Work Order ID 70179

Item ID: D412-742-043

Item Name: Replacement Float Skidtube

DRAWING NO. D3391	TITLE 412 FLOAT SKIDTUBE	REV. H	DART AEROSPACE USA, INC ENGINEERING ORDER		D.E.O. NO. D3391-H-1	SHEET NO. SHEET 1 OF 1	SCALE NTS
DRAWN <i>CP</i>	CHECKED <i>h</i>	MFG. APPR. <i>AA</i>	APPROVED <i>MP</i>		DE APPR. <i>h</i>		
DATE 09.09.23	DATE 09.09.24	DATE 09/09/25	DATE 09/09/30		DATE 09/09/30

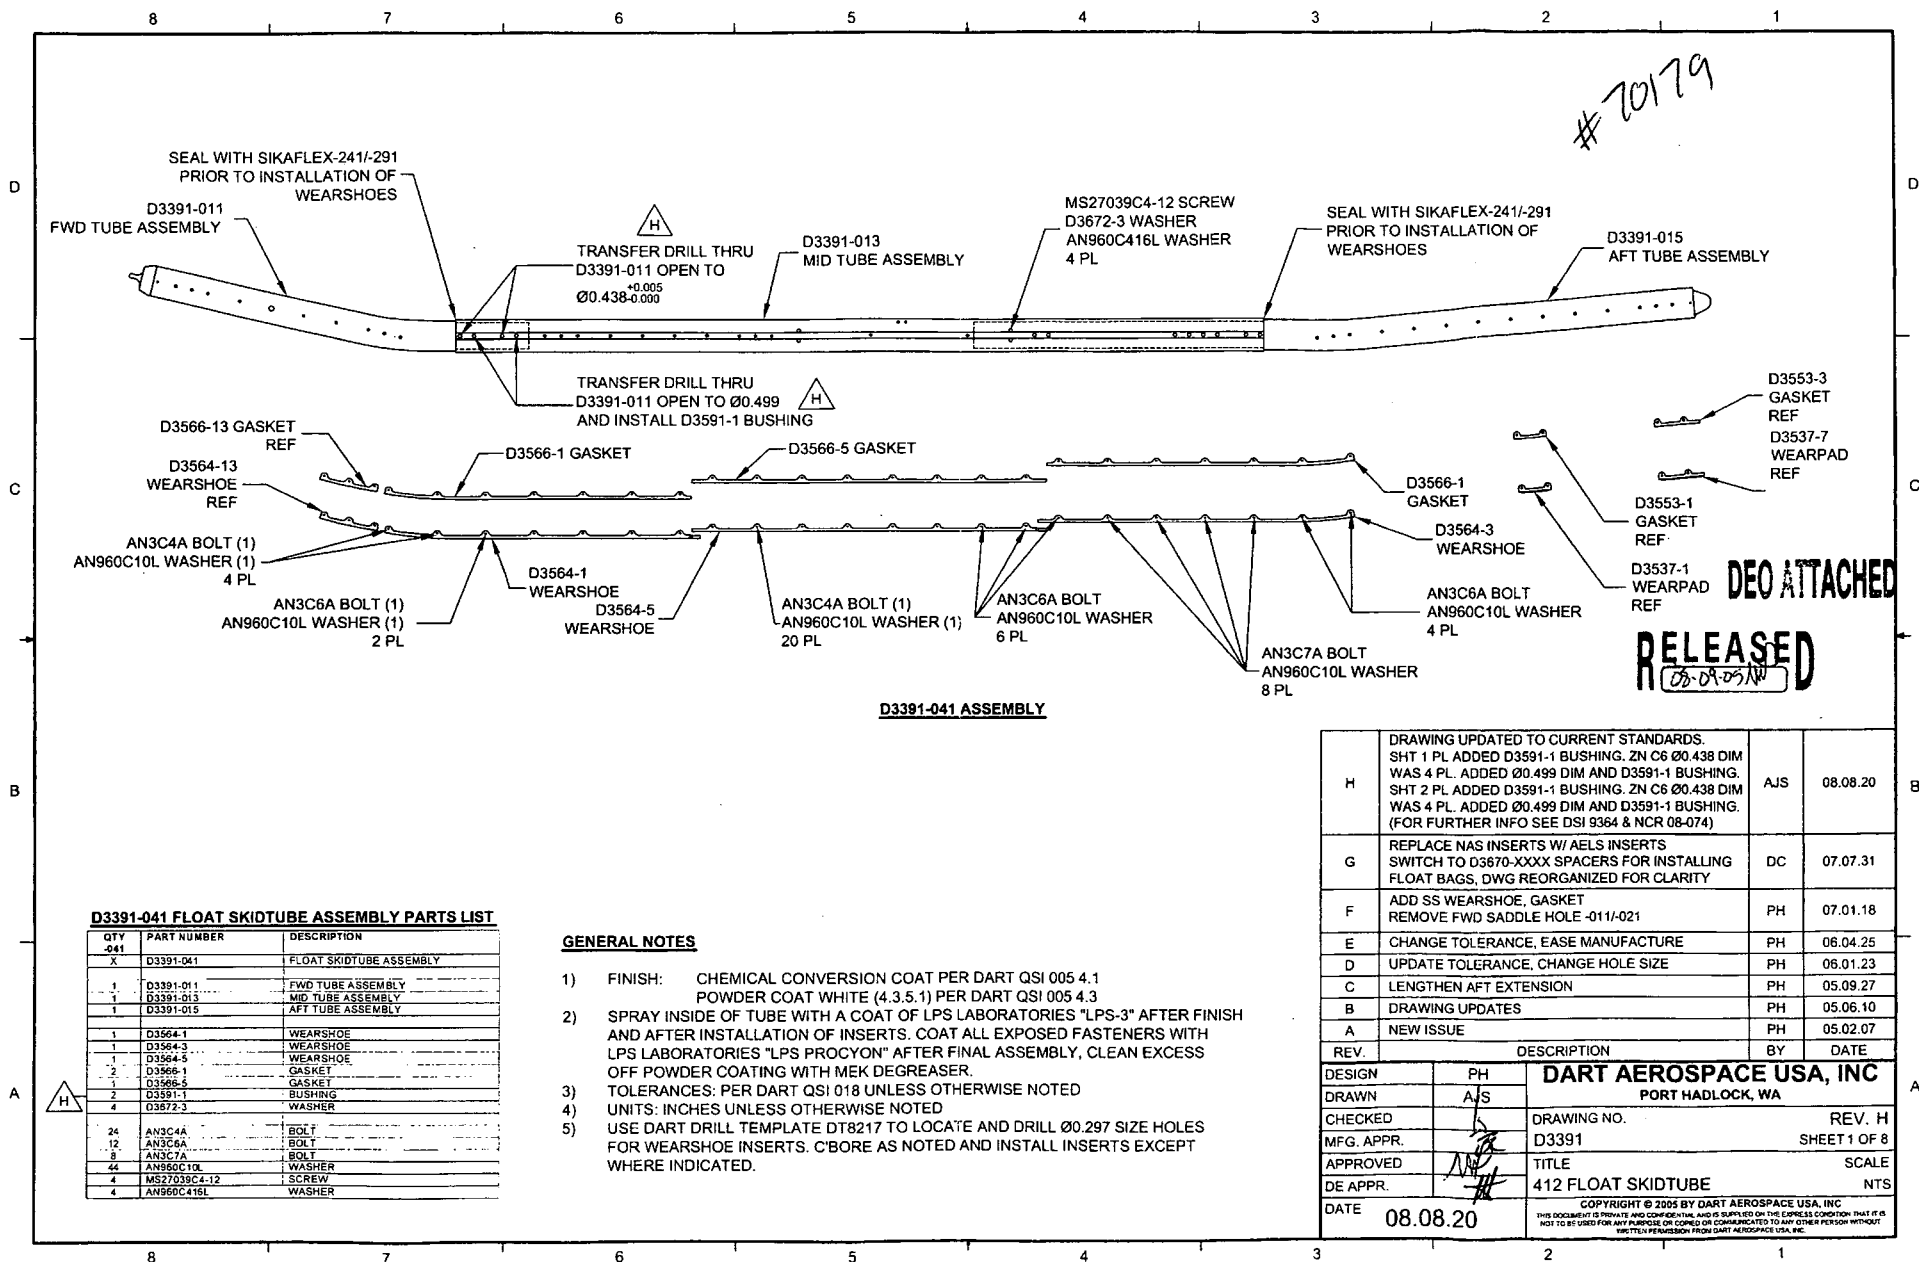
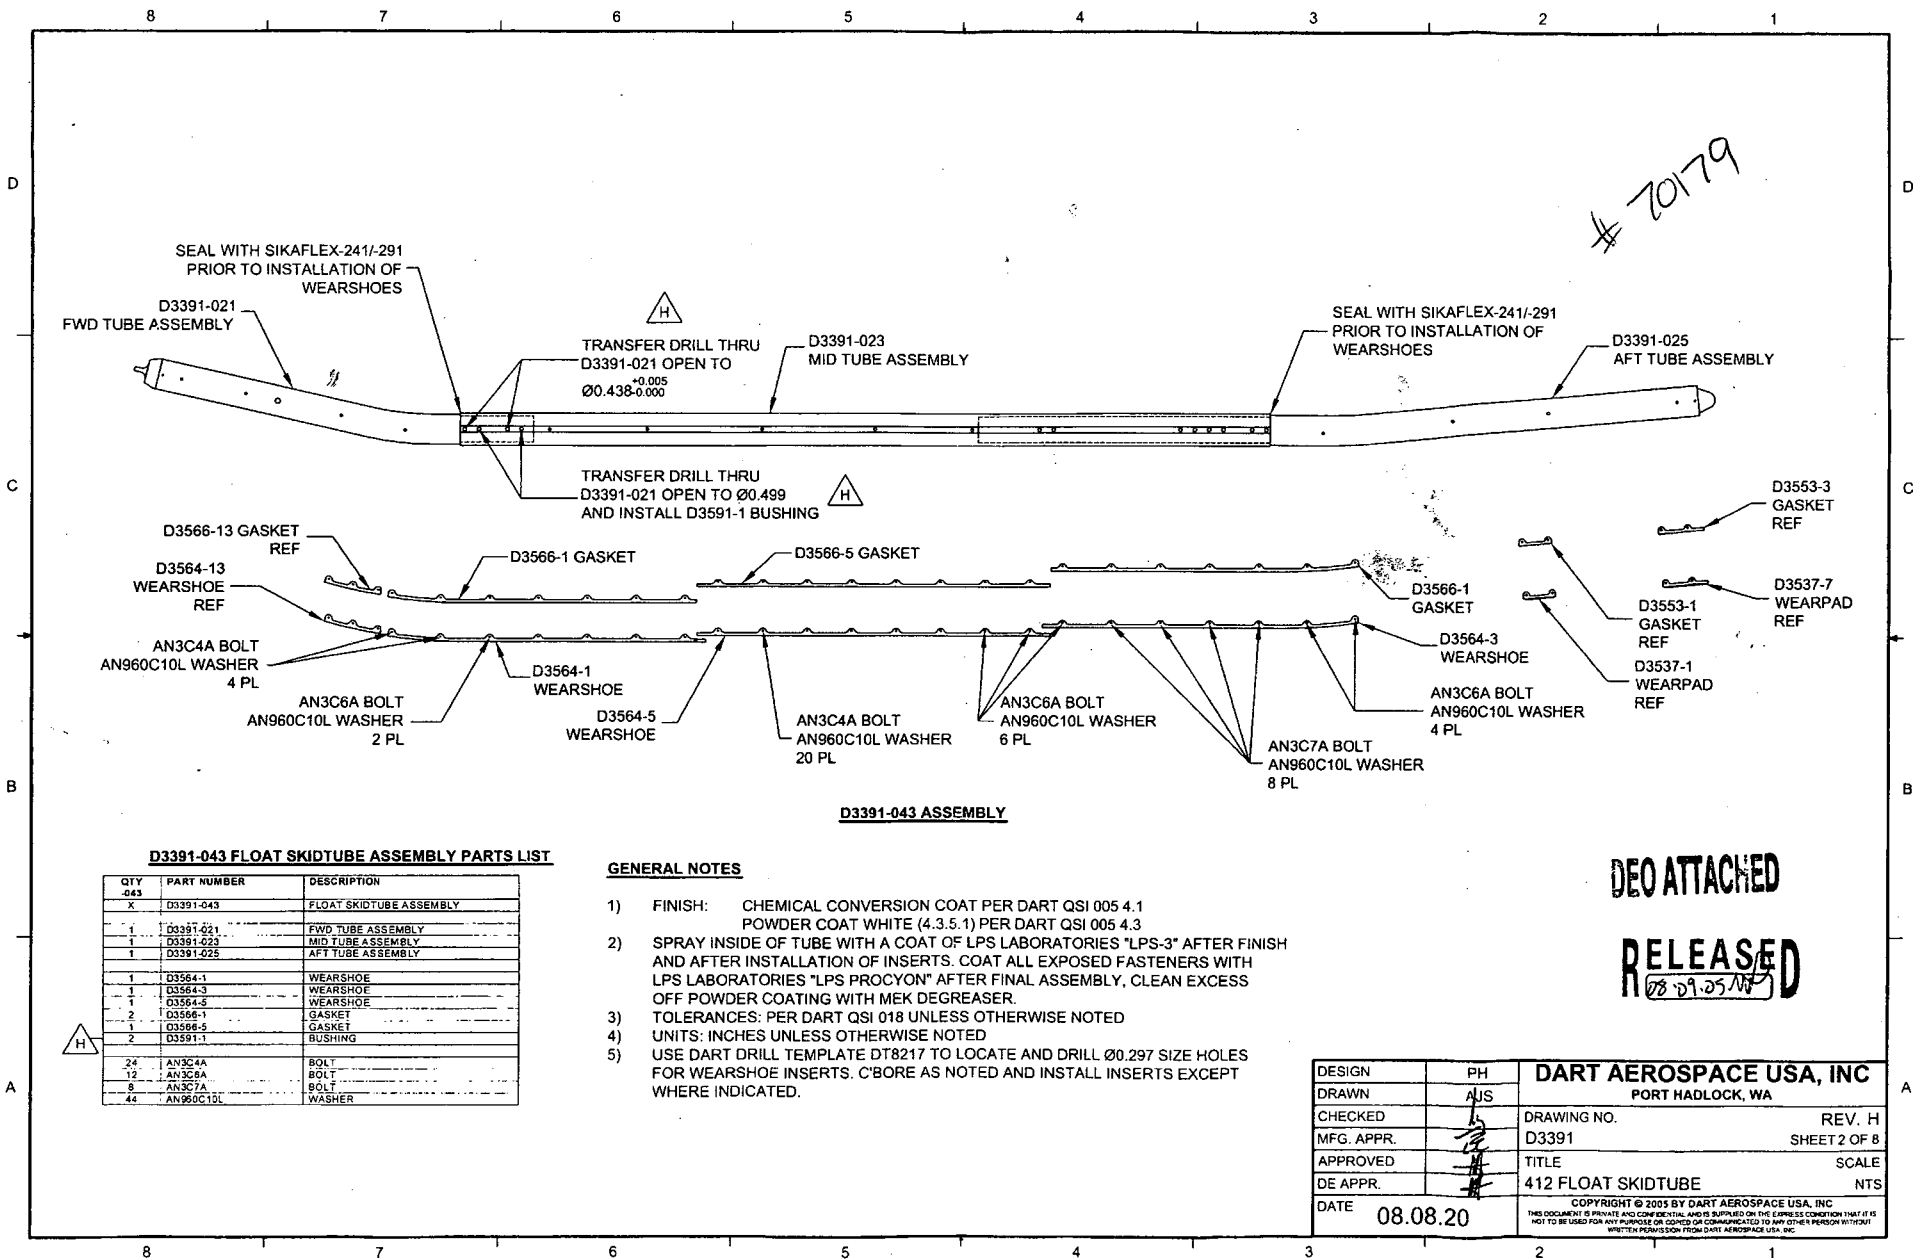
LPS-3 IS NO LONGER USED DURING ASSEMBLY OF D3391-041/-043 SKIDTUBES.

AMEND NOTE 2 OF D3391-041/-043 SKIDTUBE ASSEMBLIES (ZN A6-1, A6-2) AS FOLLOWS:

- 2) ~~SPRAY INSIDE OF TUBE WITH A COAT OF LPS LABORATORIES "LPS-3" AFTER FINISH~~
~~AND AFTER INSTALLATION OF INSERTS. COAT ALL EXPOSED FASTENERS WITH~~
 LPS LABORATORIES "LPS PROCYON" AFTER FINAL ASSEMBLY, CLEAN EXCESS
 OFF POWDER COATING WITH MEK DEGREASER.
